# CITY OF ALBUQUERQUE

November 2, 2020

**RE: 9912 Bellamah Ave NE**  
**Grading and Drainage Plan**  
**Engineer's Certification Date: 10/26/20**  
**Engineer's Stamp Date: 09/01/20**  
**Hydrology File: J20D040**

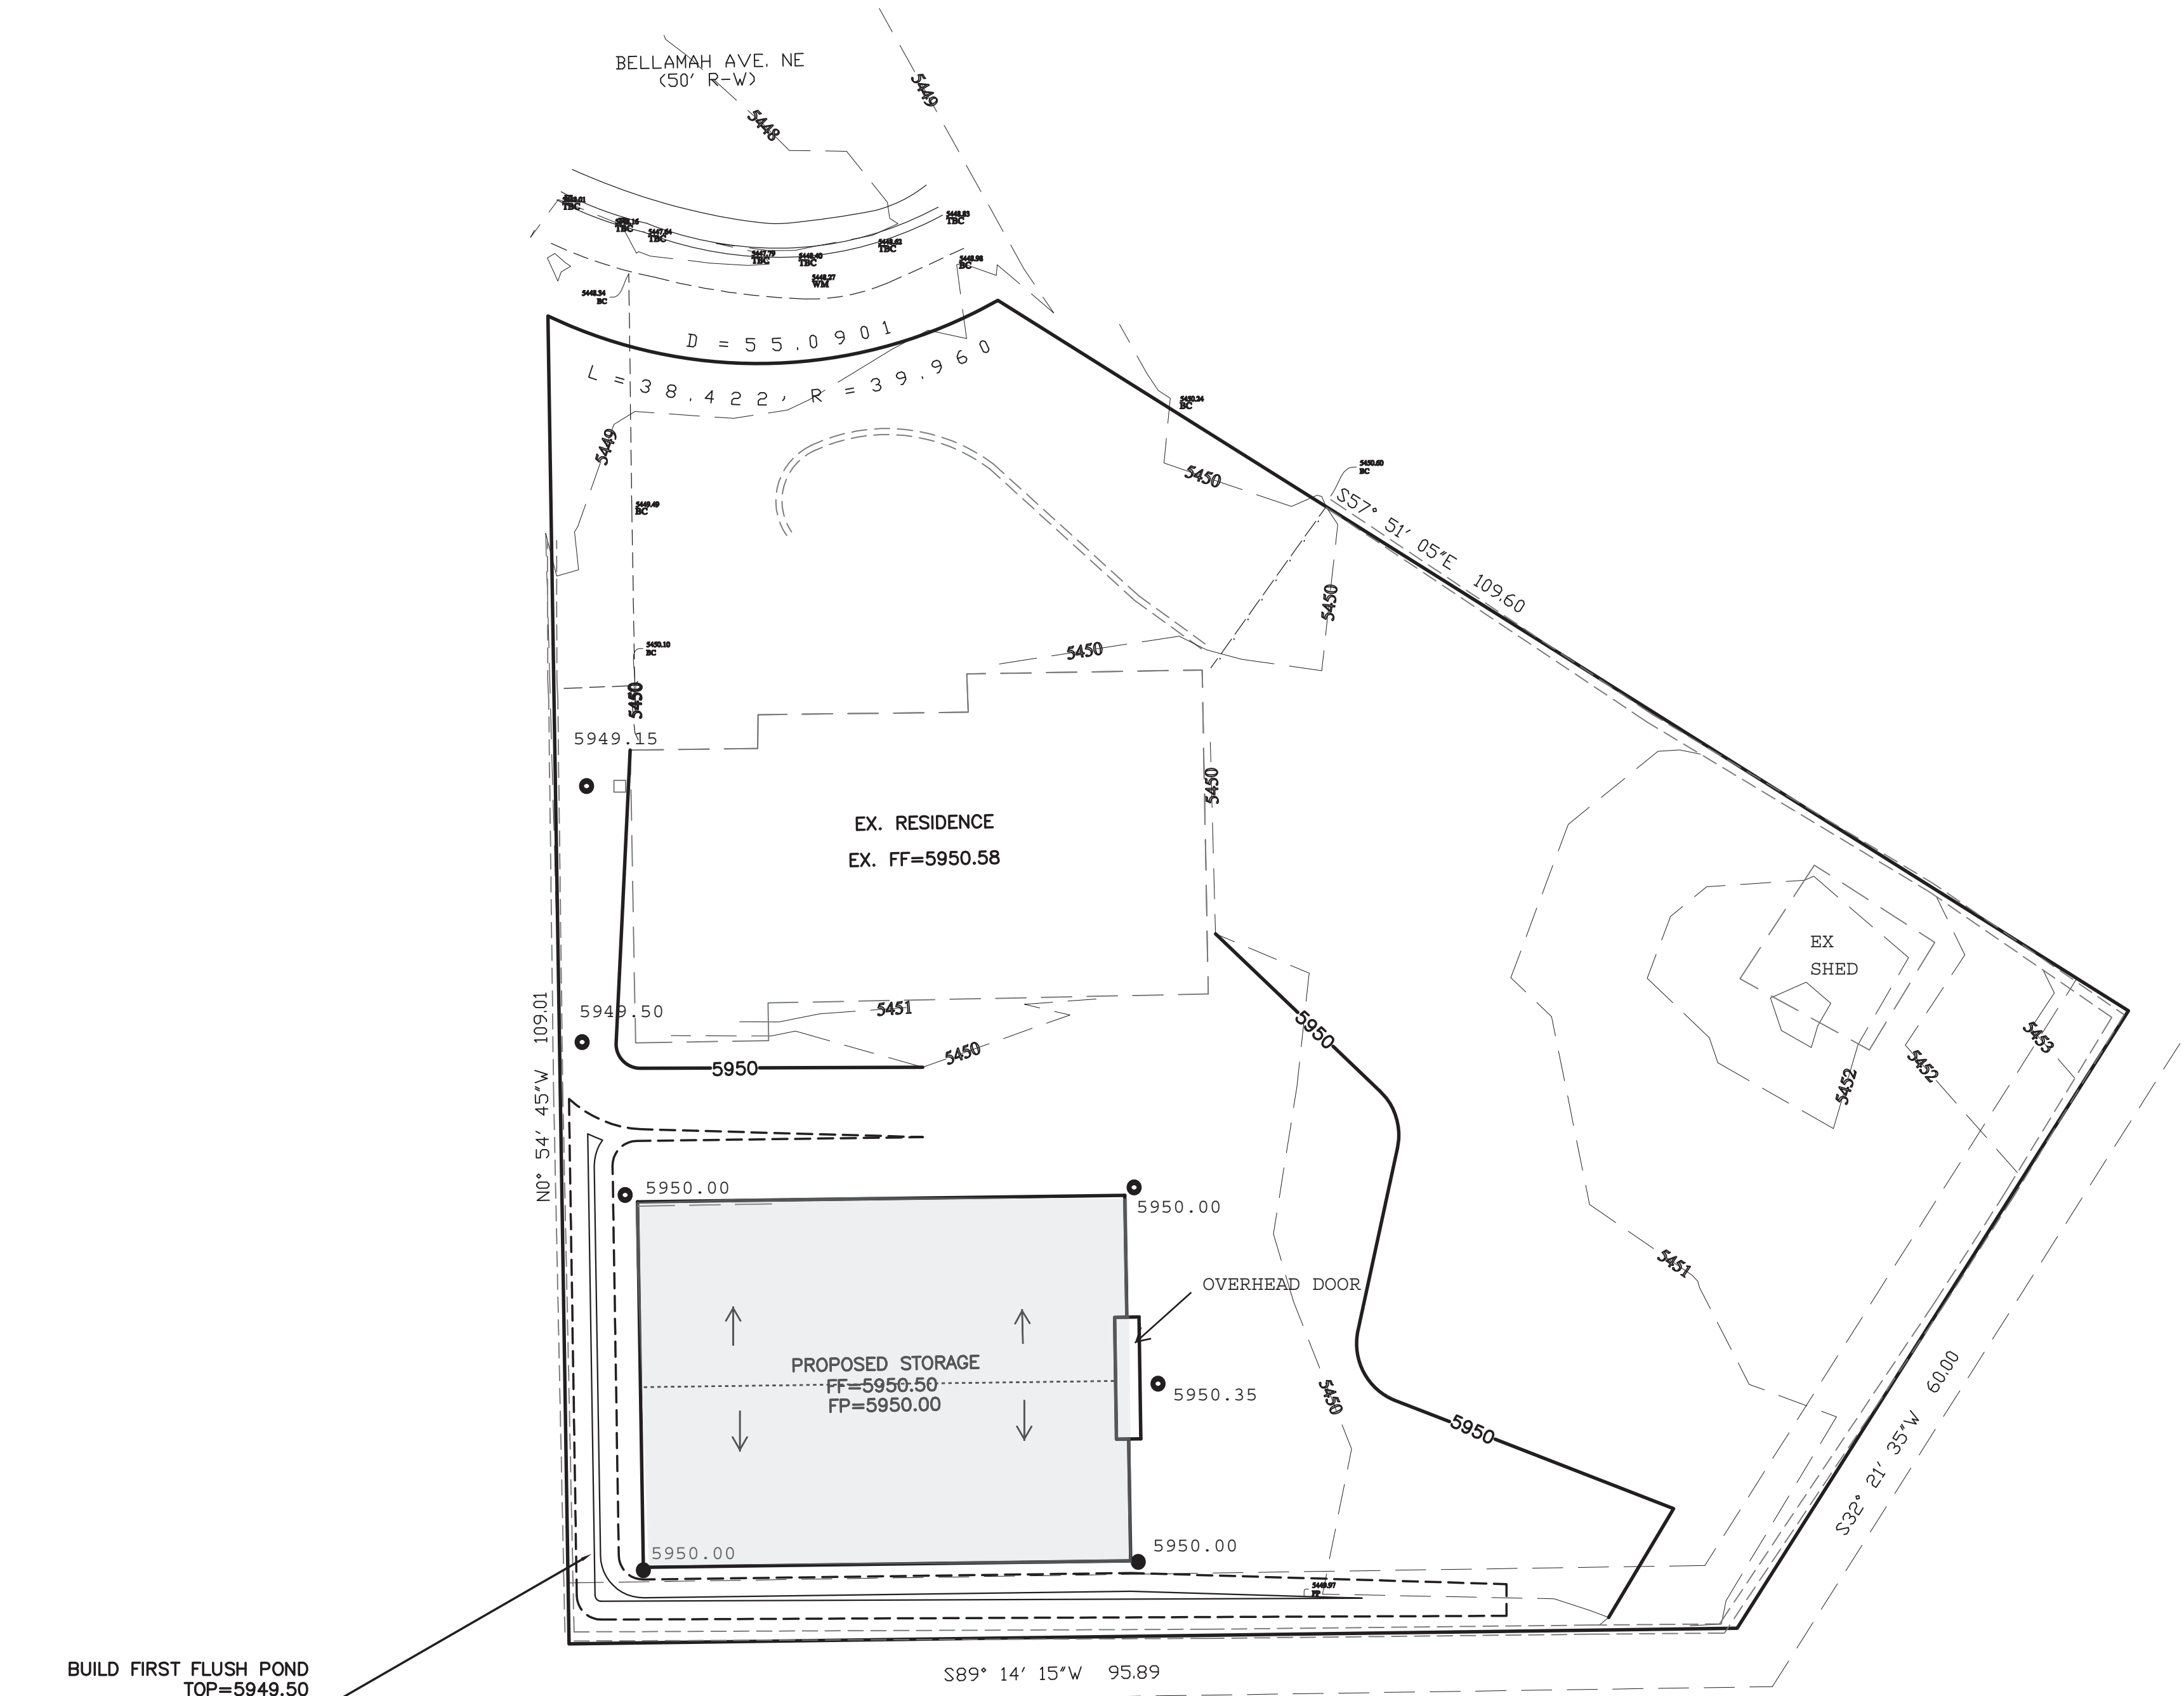
Based upon the information provided in your Certification received on 10/26/20 and site photos sent on 10/26/20, the above referenced Certification is acceptable for Building Pad Certification for 9912 Bellamah Ave NE.

Prior to approval in support of Permanent Release of Occupancy by Hydrology, Engineer Certification per the DPM checklist will be required.
